HOWIE POINT (NORTH 1)
FROM STA 0+00.00
TO STA 28+00.00

MEADOW RANCH II & III

GRADING & EROSION CONTROL PLAN COVER SHEET

C1.6

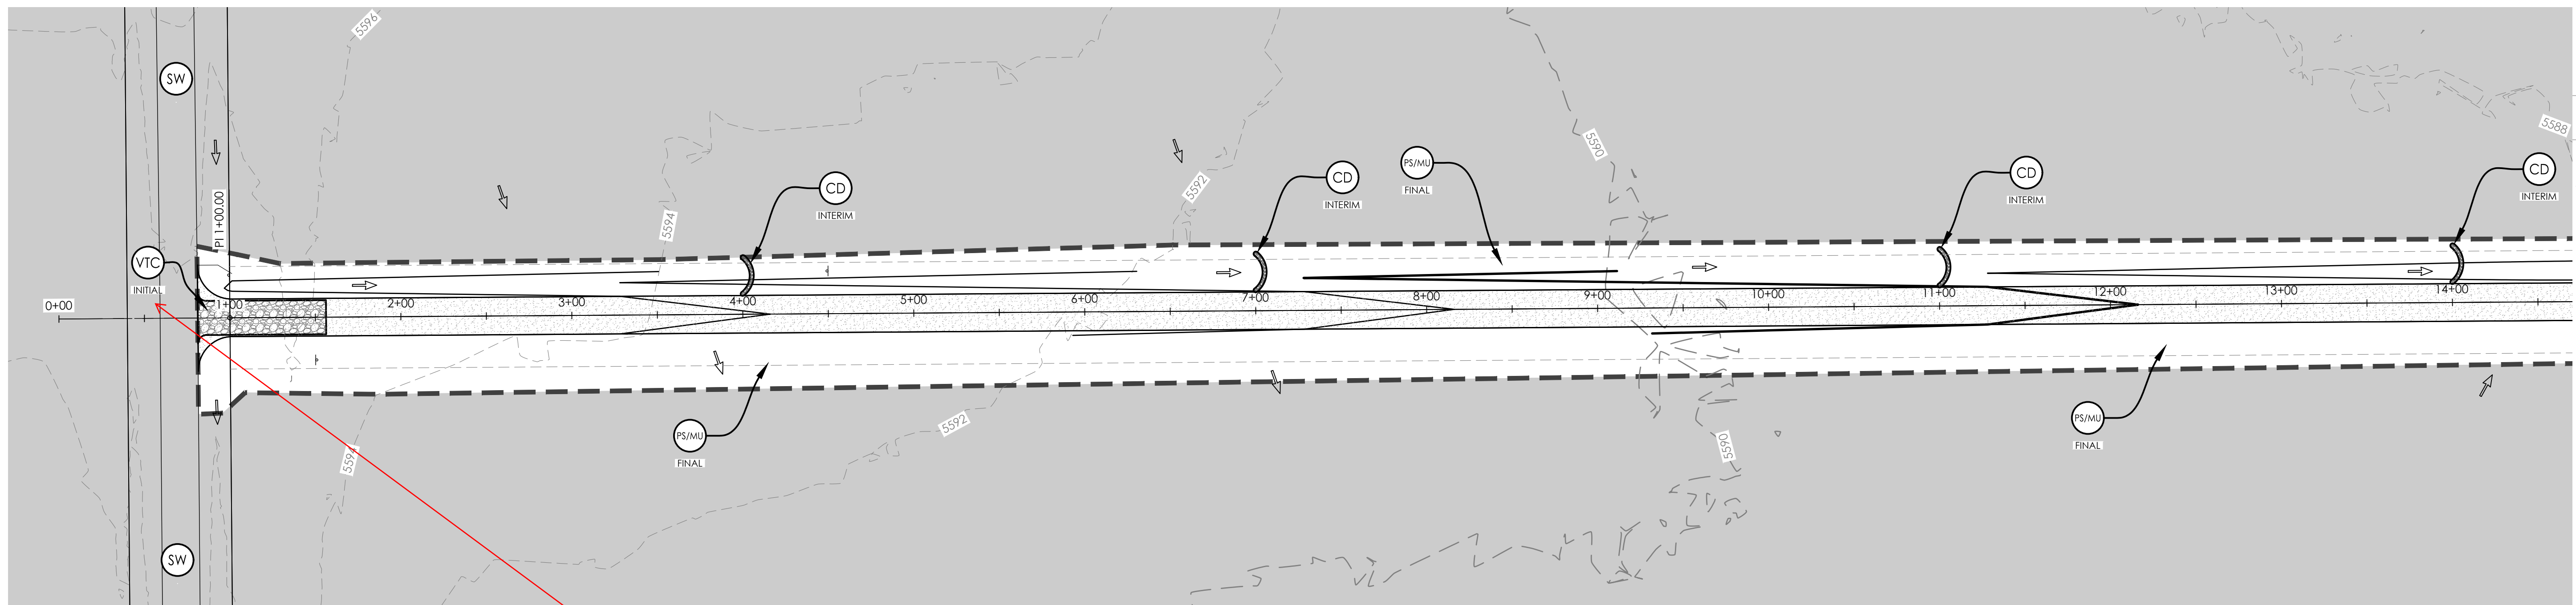
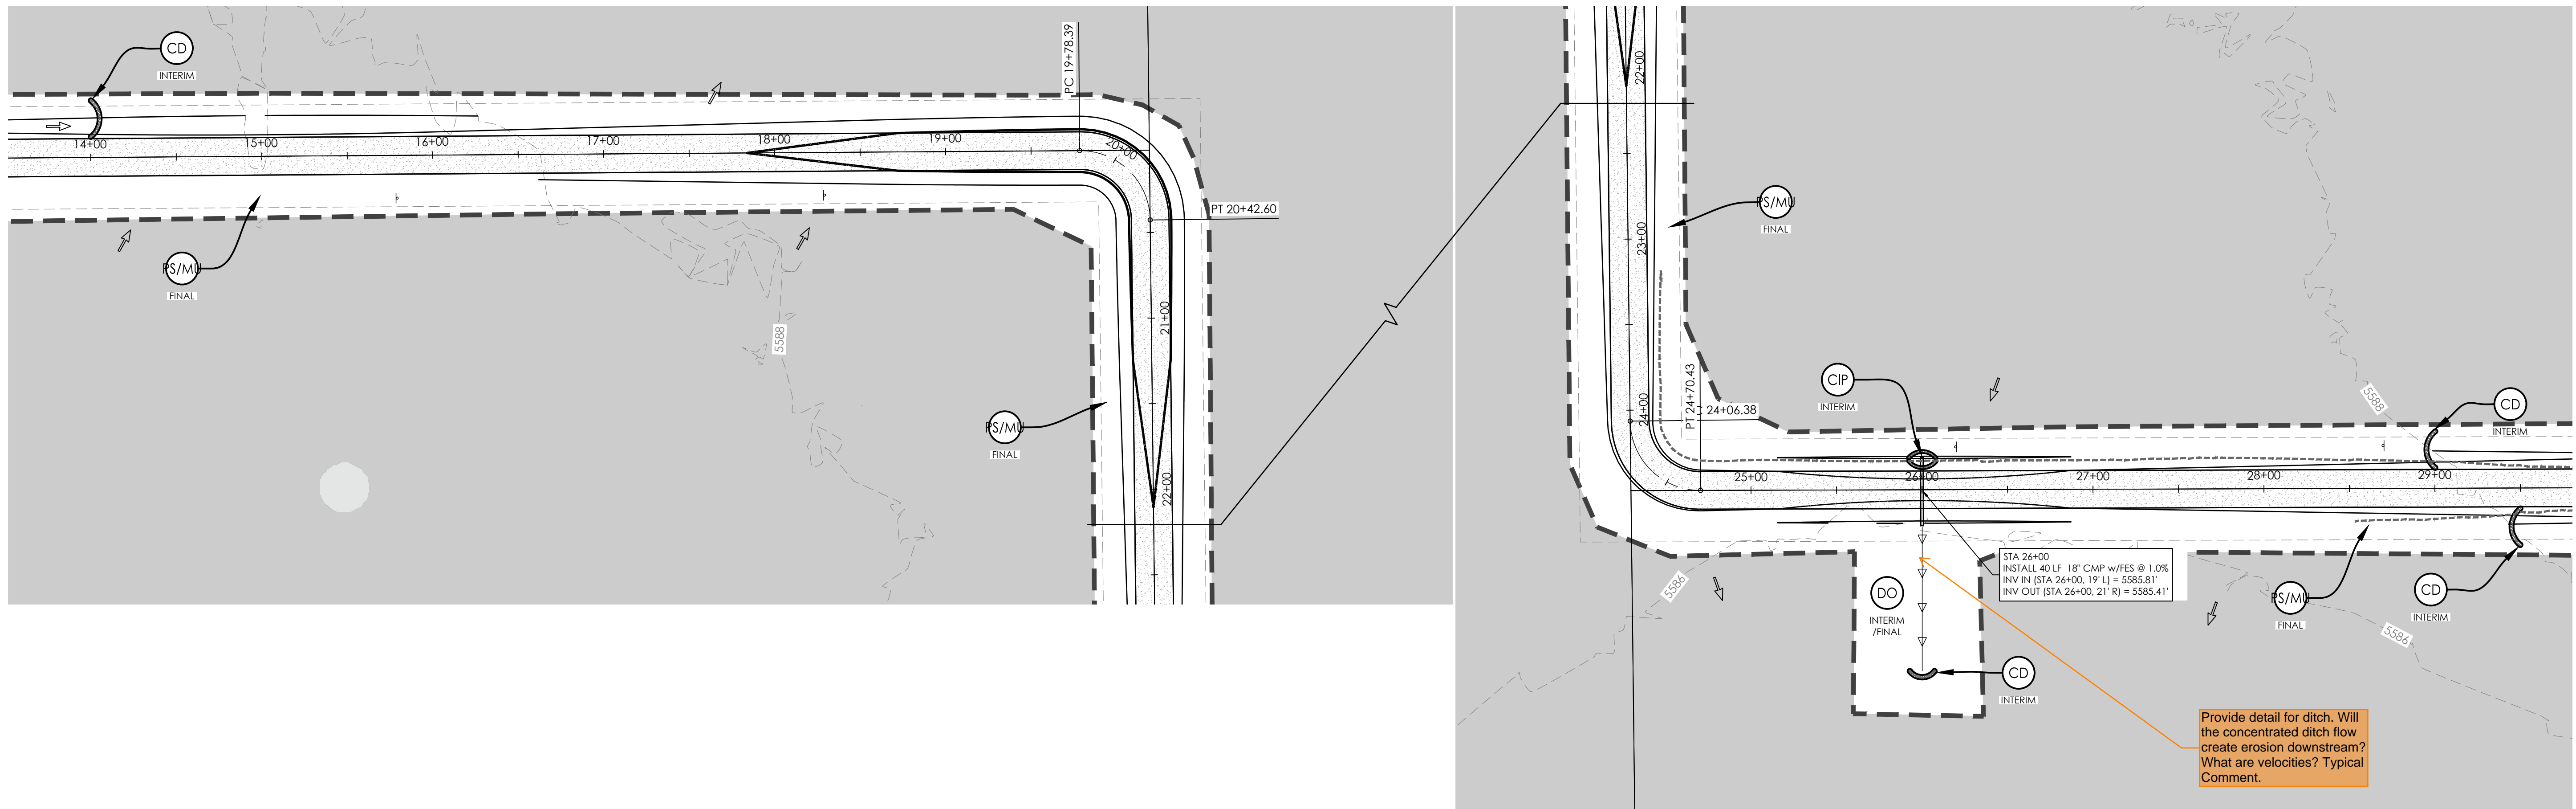
Provide details on
Meyers Rd ROW

Provide detail for ditch. Will the concentrated ditch flow create erosion downstream? What are velocities? Typical Comment.

C1.9

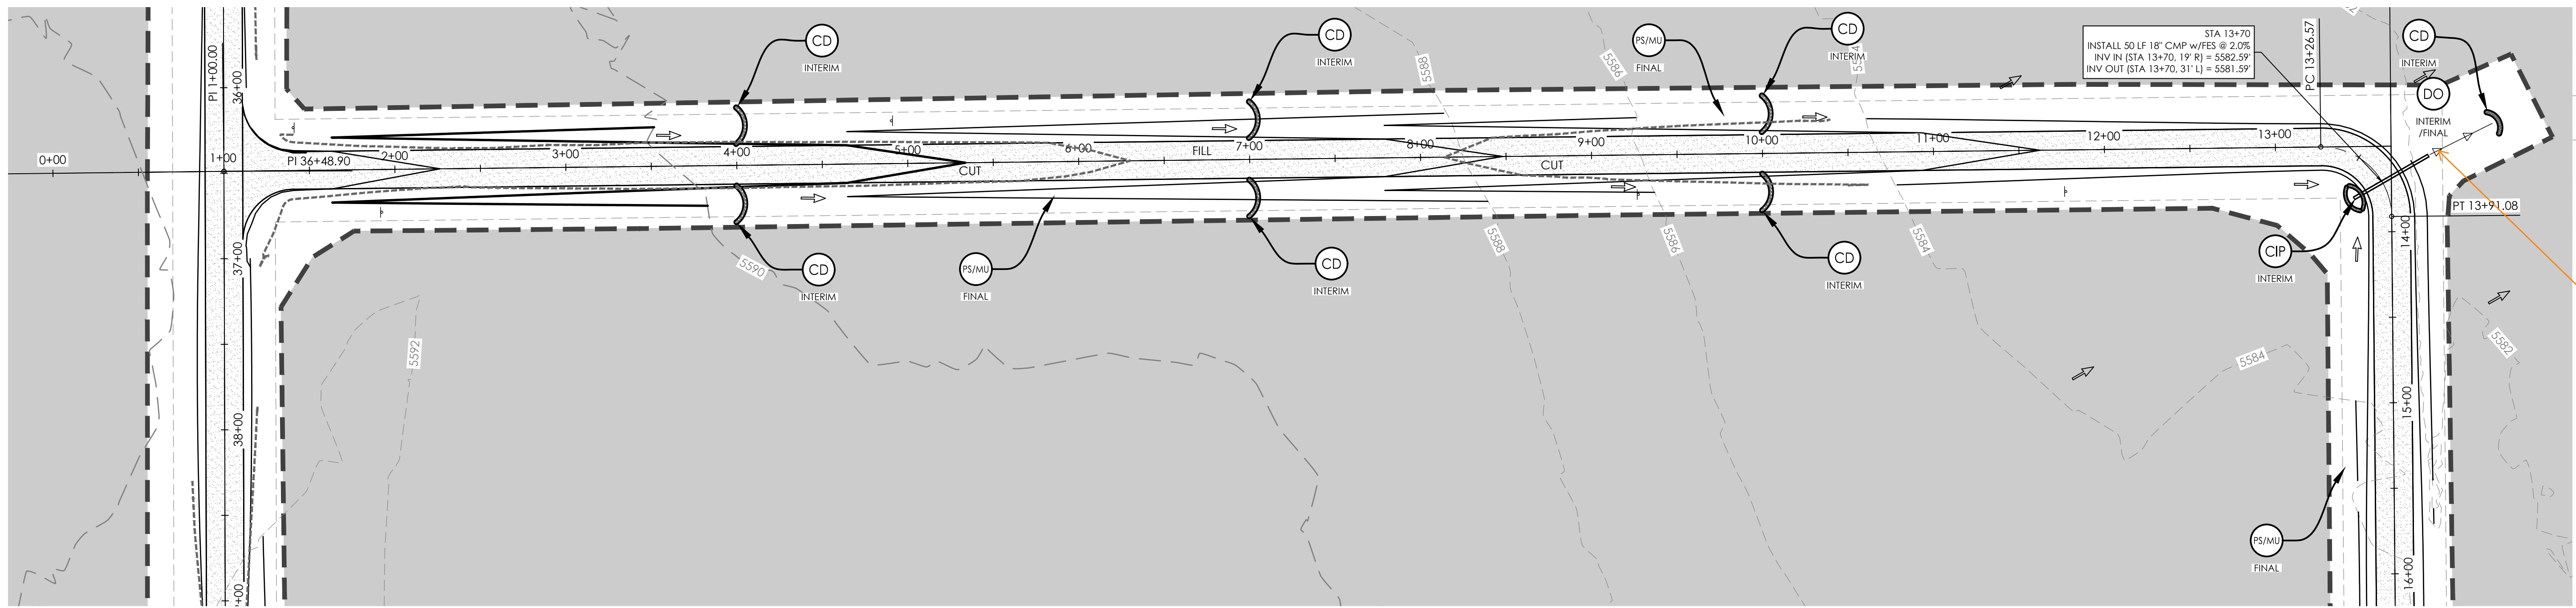
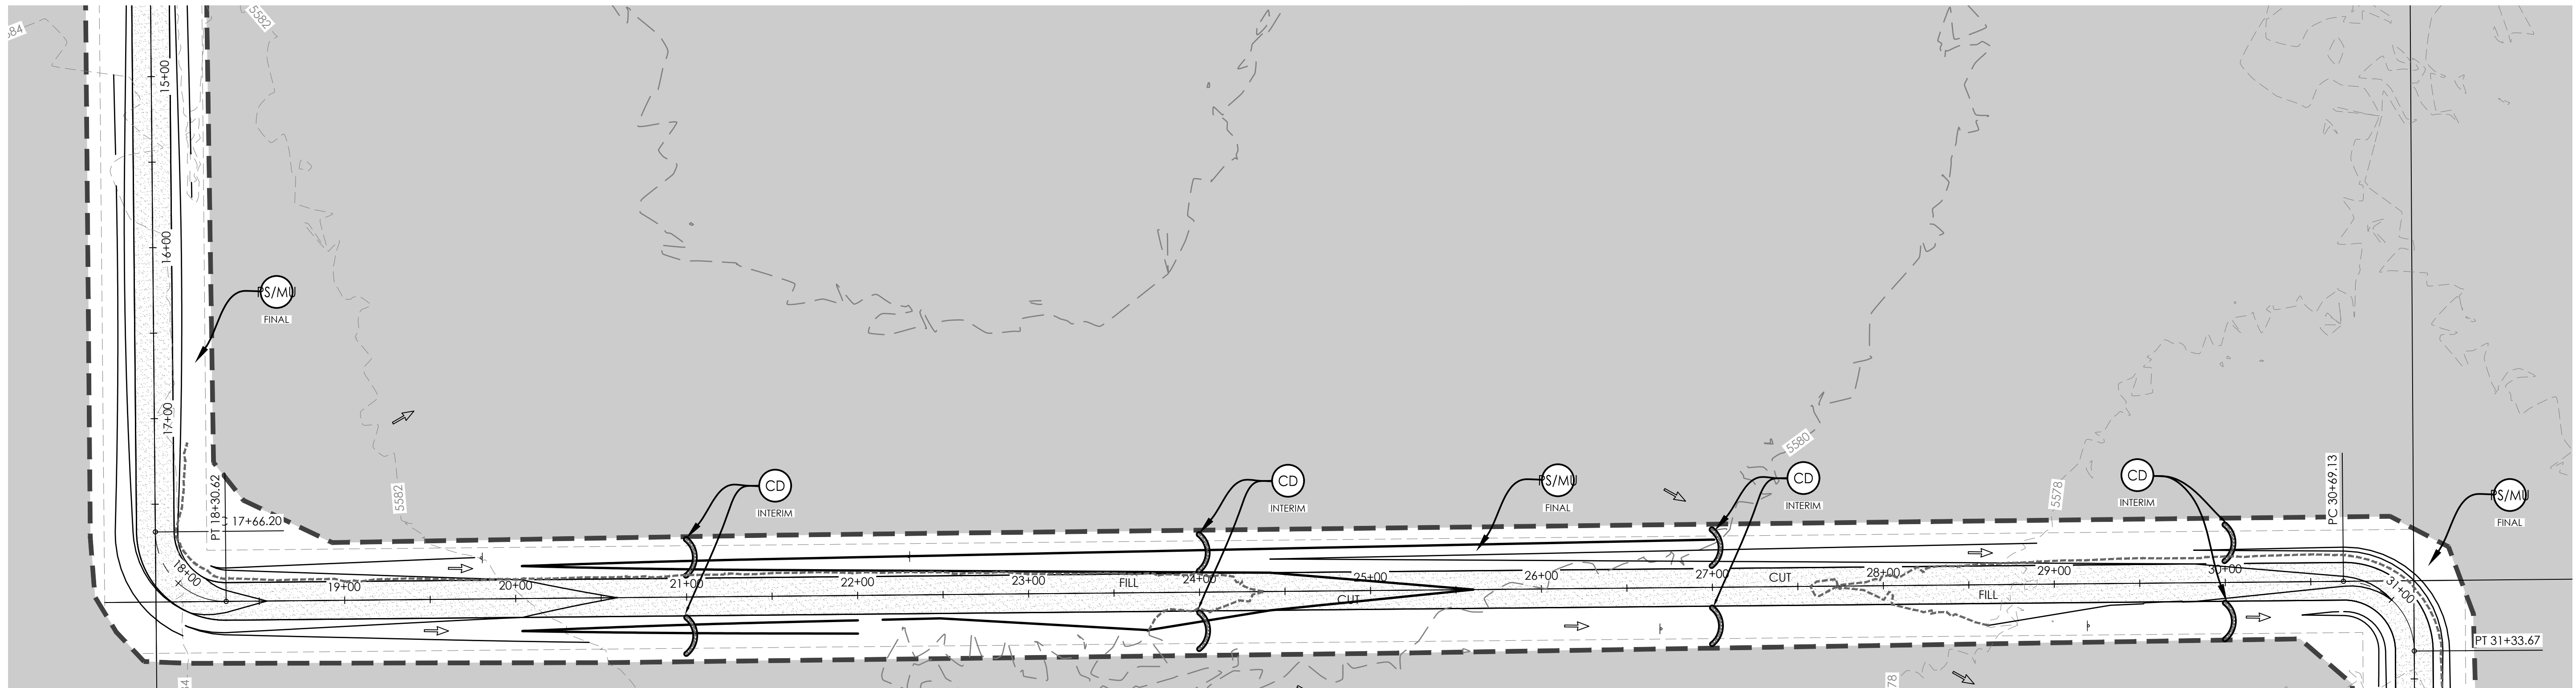
Provide detail for ditch. Will the concentrated ditch flow create erosion downstream? What are velocities? Typical Comment.
